# Access Compliance Report

## Public Rights-of-Way

Intersection ID: 3194	Main Street: HIGHCROFT_LN	Cross Street: OLD_BRIDGE_LN	Location: SW
ADA ID: 704FA6999FAE	Ramp Type: Perp	Initial Pass/Fail: Fail	Overall Compliance: No
Severity Score: 12.5			
Codes/Mitigation Info/Possible Solution		Field Measurements/Component Compliance

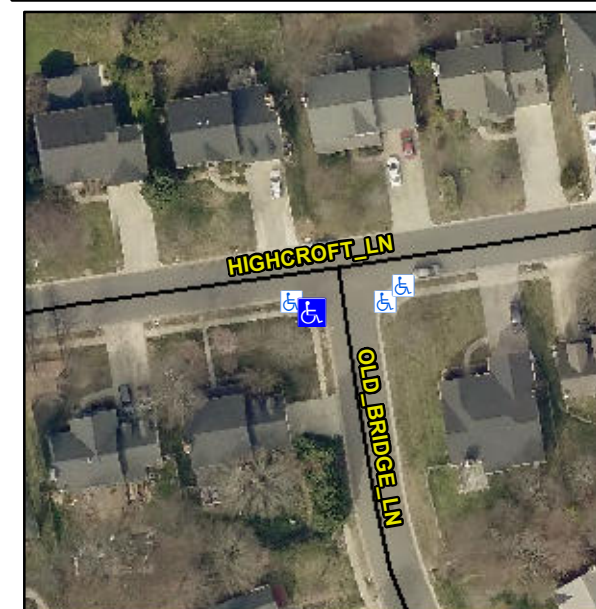
**Not Found, R304.5.3**

Compliance	Description	Data	Compliance	Description	Data
N/A	Ramp Length (in)	48.0	Yes	Ramp Slope (%)	5.0
Yes	Ramp Width (in)	48.0	No	Ramp XSlope (%)	6.8
N/A	Flare Type LT	N/A	N/A	Flare Type RT	N/A
N/A	Flare Slope LT (%)	N/A	N/A	Flare Slope RT (%)	N/A
N/A	Flare Traversable LT?	N/A	N/A	Flare Traversable RT?	N/A
N/A	Landing Length (in)	N/A	N/A	DWS Provided?	N/A
N/A	Landing Width (in)	N/A	N/A	DWS Contrast?	N/A
N/A	Landing Slope (%)	N/A	N/A	DWS Length (in)	N/A
N/A	Landing X Slope (%)	N/A	N/A	DWS Full Width?	N/A
N/A	Landing Curb? (Y/N)	N/A	N/A	DWS Offset (in)	N/A
N/A	Shared Landing?	N/A			
N/A	Gutter Ponding?	N/A	N/A	Gutter Slope (%)	N/A
N/A	Gutter Lip Ht (in)	N/A	N/A	Gutter X Slope (%)	N/A
N/A	Painted X Walk1?	No	N/A	Painted X Walk2?	N/A
	X Walk 1 Direction	To E		X Walk 2 Direction	N/A
N/A	X Walk 1 Width (in)	N/A	N/A	X Walk 2 Width (in)	N/A
	X Walk 1 Slope (%)	0.2		X Walk 2 Slope (%)	N/A
	X Walk 1 X Slope (%)	4.0		X Walk 2 X Slope (%)	N/A

**Remove & Replace Entire Ramp.**
